Response to Final Report Review Comments

ECE 445 Senior Design Laboratory

AI Navigation Glasses for the Visually Impaired

Figure 1: Overall architecture of the AI-powered wearable assistive perception system, showing the hardware, communication, backend processing, AI perception, assistive decision-making, and feedback/output subsystems.

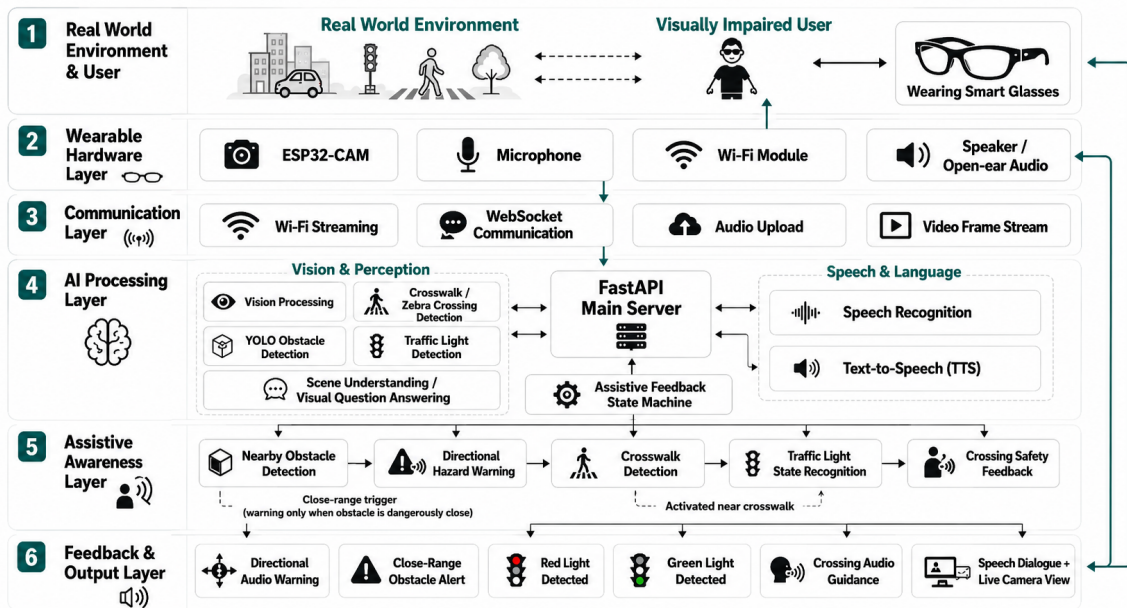
Reviewer Comment: *Provide visual aid including all major subsystems and block diagram.*

Response: We agree with the reviewer that the original Introduction did not provide a sufficiently explicit top-level architectural visualization of the complete system.

To address this, we added a new large-format system overview diagram to the Introduction. The revised diagram presents the full end-to-end architecture of the proposed wearable assistive navigation system and explicitly illustrates the major subsystem decomposition and their functional interconnections.

Revision Implemented: A new introduction-level system architecture figure was added to explicitly present all major subsystems and their interconnections.

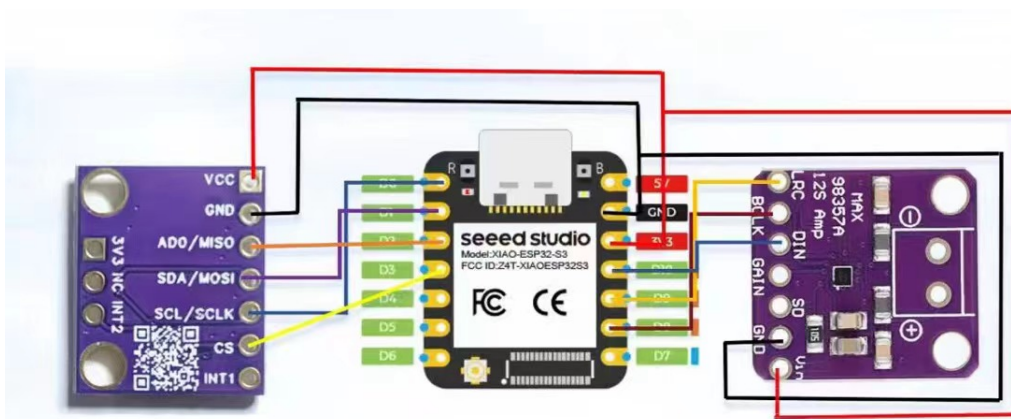
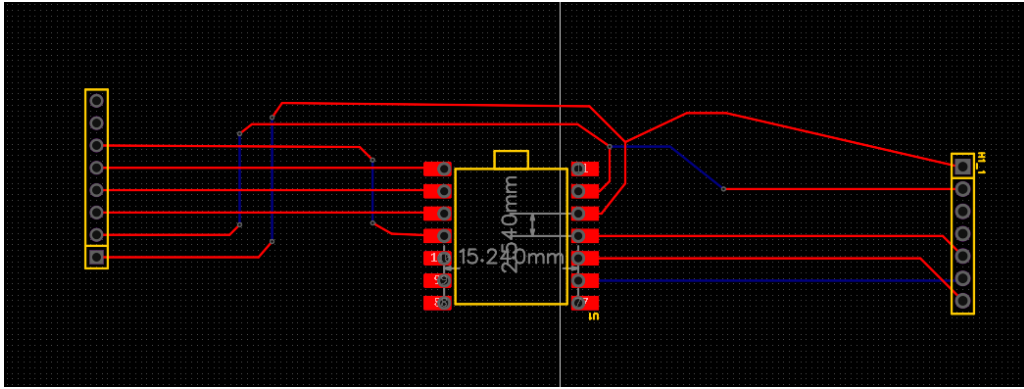
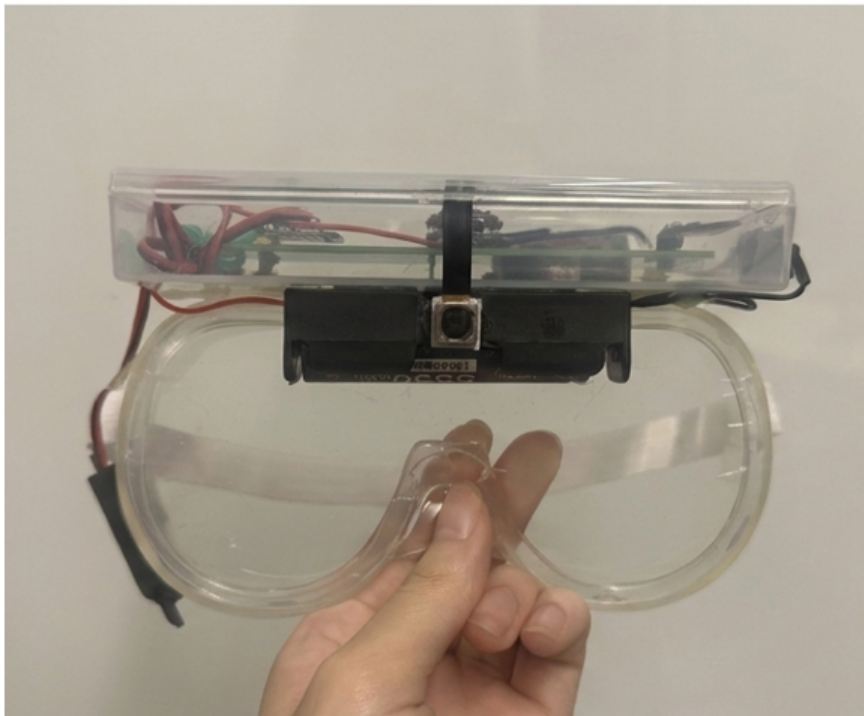
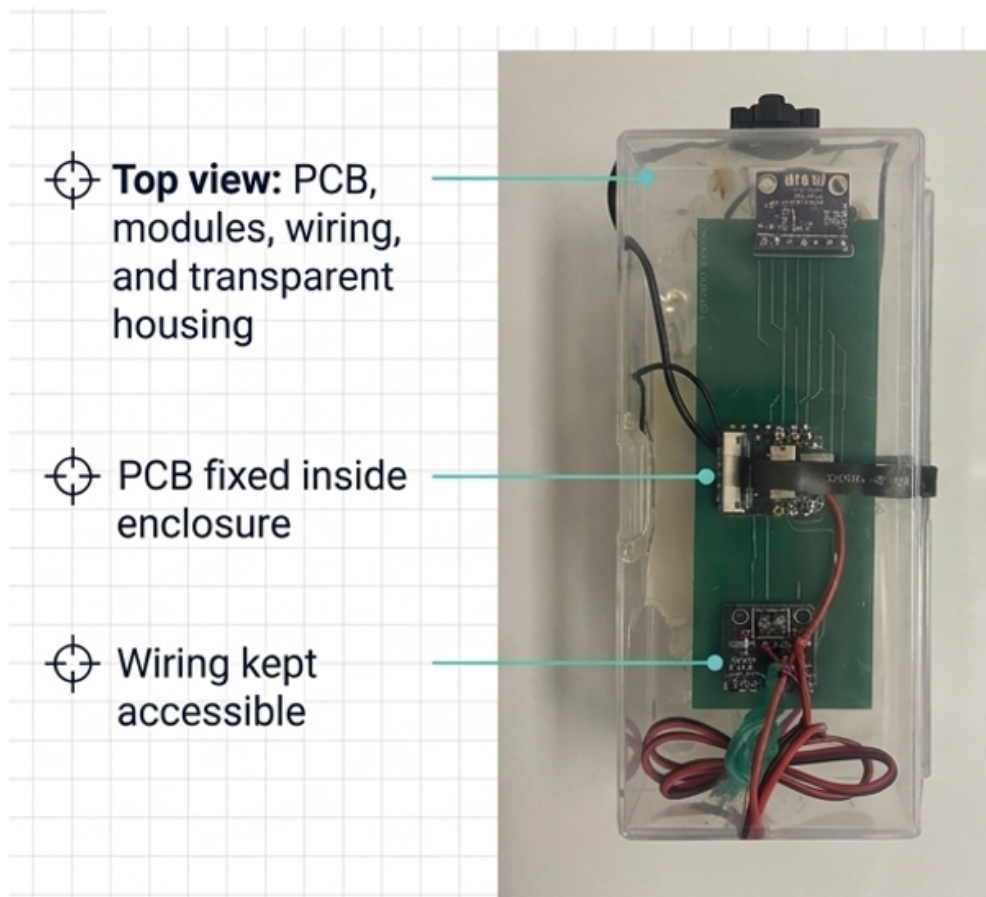
Reviewer Comment: Provide detailed physical design. Describe power supply including battery and voltage regulation circuits.

Response: We agree that the original report did not provide enough detail about the physical hardware implementation and power architecture. The previous Design section focused mainly on the system architecture, vision pipeline, audio pipeline, and navigation logic, but it did not sufficiently explain how the wearable prototype was physically assembled, how the electronics were protected, or how the final prototype was powered.

To address this comment, we added a new Design subsection titled “Physical Prototype and Power Architecture.” This subsection now describes the final hardware implementation of the wearable glasses prototype. The final prototype uses an OV5640 camera, a Seeed Studio XIAO ESP32-S3 Sense controller, a MAX98357 I2S audio amplifier, and a 3718 enclosed 8 Ω 2 W speaker. The IMU was considered in the early design stage, but it is not used in the current final prototype; therefore, the revised Design section explicitly removes the IMU from the implemented hardware list to avoid overstating the final implementation.

We also expanded the power supply description. The final prototype is powered by a replaceable 5 V lithium battery pack rated at 12580 mWh. The battery output is connected to the XIAO ESP32-S3 Sense board through a physical power switch, allowing the prototype to be turned on and off directly. The ESP32-S3 Sense board receives the 5 V input and uses its onboard voltage regulation circuitry to generate the regulated logic rails required by the microcontroller and attached modules. In other words, the final prototype does not use a separate external regulator board; the voltage regulation stage is implemented by the onboard regulator of the XIAO ESP32-S3 Sense, which converts the 5 V battery input into the regulated logic supply required by the ESP32-S3 and attached low-voltage modules. The OV5640 camera and MAX98357 amplifier are powered from the ESP32-S3 Sense board power rails, and all modules share a common ground. No separate external charging module is used in the final prototype because the battery pack is replaceable rather than recharged inside the device.

To make the physical and electrical design clearer, the revised report adds a color-coded wiring diagram, a PCB routing figure, and close-up photographs of the assembled electronics enclosure. The wiring diagram explains the module-level physical connections among the ESP32-S3 Sense, peripheral modules, power, ground, and audio output path. The PCB routing figure shows how the power, ground, and signal traces are organized to reduce loose jumper wiring and improve physical integration. The added front and top-view prototype photographs show that the PCB, controller, amplifier, and wiring are physically integrated inside the transparent enclosure, while the camera and battery are mounted below the enclosure to support rain protection and heat management.

Revision Implemented: Added a new Design subsection titled “Physical Prototype and Power Architecture.” This section now documents the final hardware list, component placement, wearable mounting rationale, transparent electronics enclosure, 5 V battery supply, physical power switch, onboard voltage regulation through the XIAO ESP32-S3 Sense board, shared-ground wiring, PCB routing, physical wiring diagram, and final enclosure photographs. The revised text also clarifies that the IMU is not used in the current final prototype.

Figure 6: Revised large-font overall system architecture diagram.

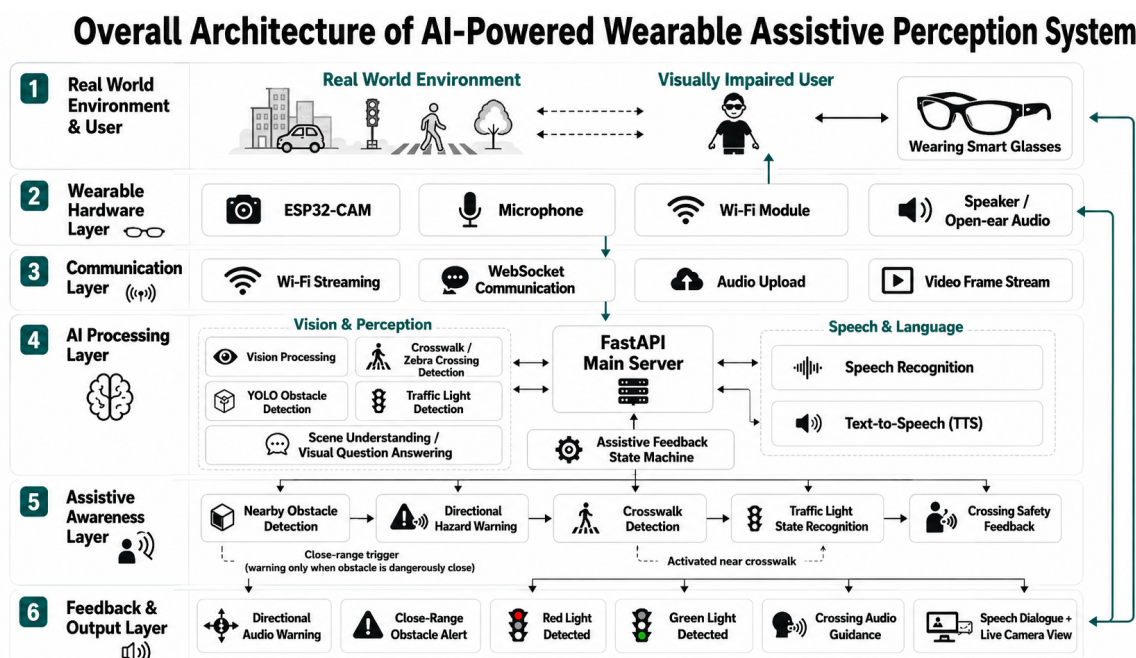
Reviewer Comment: *Increase fonts in Figure 1. Too small to be seen.*

The architecture figure was redrawn at higher resolution with enlarged labels, simplified routing arrows, increased spacing between functional blocks, and reduced visual clutter.

Revision Implemented: The introductory visual aids were revised for readability. Figure 1 was replaced with a higher-resolution large-font architecture diagram, and the subsystem summary table was reformatted with larger text and improved spacing.

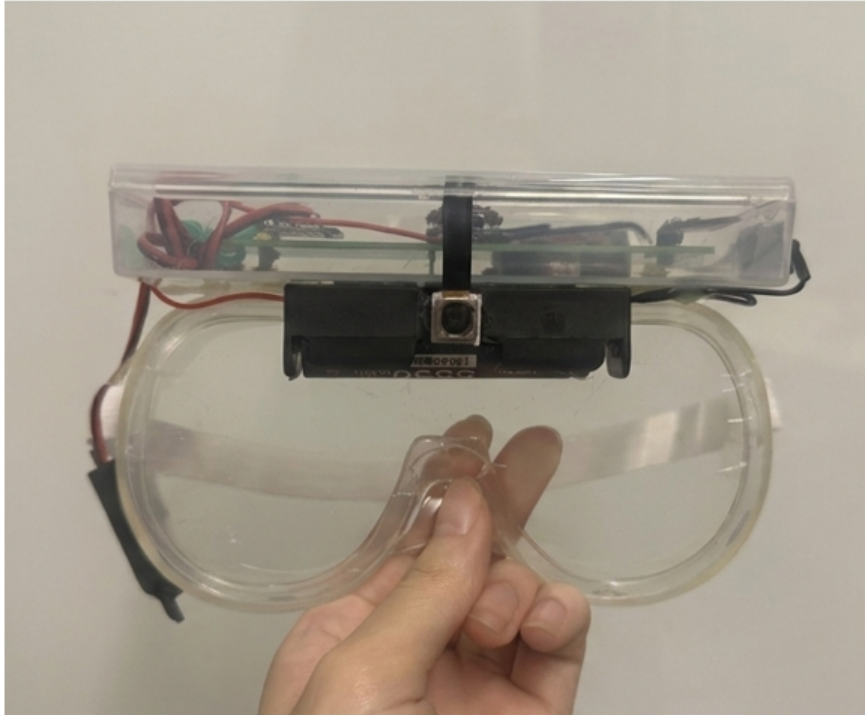
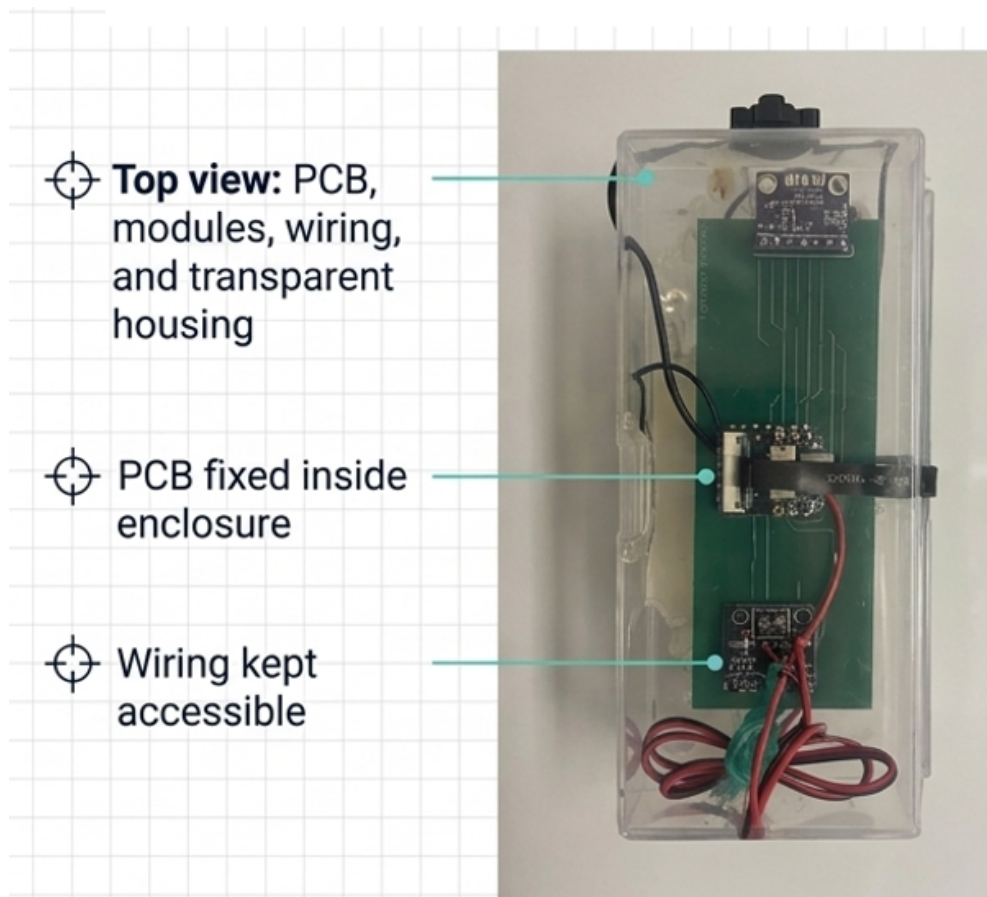
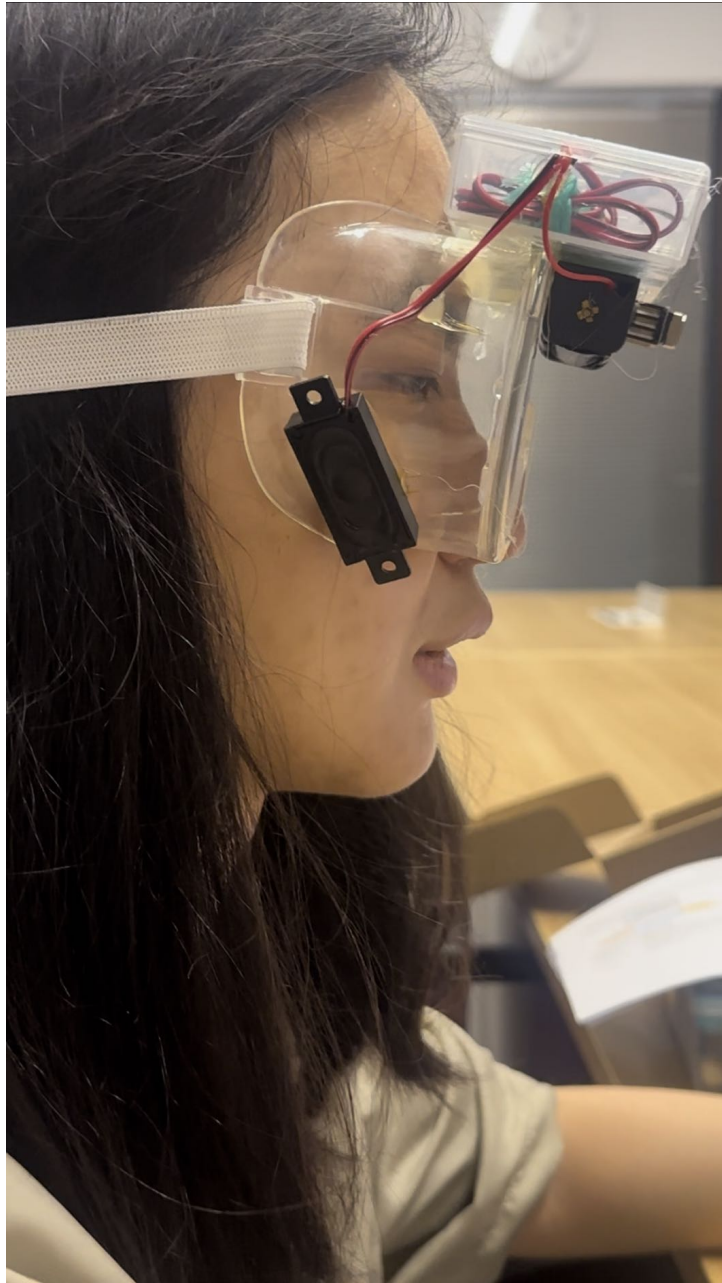
Reviewer Comment: *Provide figures and photos of final prototype.*

Response: We agree that the original report did not provide enough visual evidence of the final physical prototype. To address this comment, we added final prototype photographs to the Design section. The added figures show the actual wearable prototype from the front, top, and side views, including the front-mounted OV5640 camera, the transparent upper electronics enclosure, the routed wiring, the internal PCB, the ESP32-S3 Sense board, the MAX98357 amplifier, the battery placement, and the speaker mounted near the user’s ear.

These figures demonstrate that the system was physically integrated into a wearable glasses form factor rather than only described as a block diagram or software pipeline. The revised captions also explain the purpose of the physical layout: the camera is positioned near the front of the glasses to capture the user’s forward view, the PCB and electronics are enclosed for protection and physical stability, the battery is separated from the main enclosure to reduce heat buildup, and the speaker is placed close to the ear to improve the audibility of navigation prompts.

Revision Implemented: Added final prototype photographs to the Design section. The new figures document the assembled wearable prototype, including front-view camera and battery placement, top-view PCB/electronics integration, and side-view speaker and wearable placement. The figure captions were expanded to explain how the physical layout supports the intended wearable navigation use case, rain protection, wiring stability, and heat management.
